Service Bulletin

Bulletin No.: 22-NA-165

Subject: Brake Squeal Noise at Low Speeds (Pursuit Rated Option)

Brand:	Model:	Model Year:		VIN:		Engine:	Transmission:
		from	to	from	to		
Chevrolet	Silverado 1500	2023	2024				
	Tahoe PPV	2021

6581016

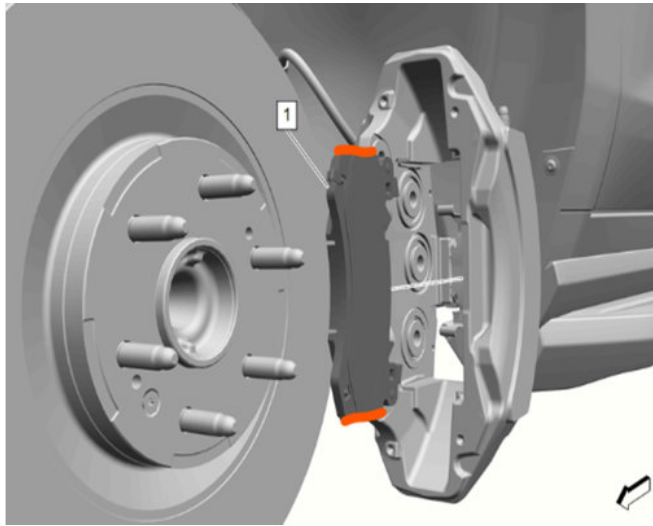
2. Apply approximately 0.09-0.15 g (0.003-0.005 oz) of copper past PN# 19303310 (PN# 19303311 Canada) or equivalent on the brake pad abutments (1), as shown in the picture above, which contacts the brake caliper.

Important: DO NOT get any copper paste (grease) on the friction face, **OR** any of the rubber components of the caliper, **OR** on the back of the brake pad.
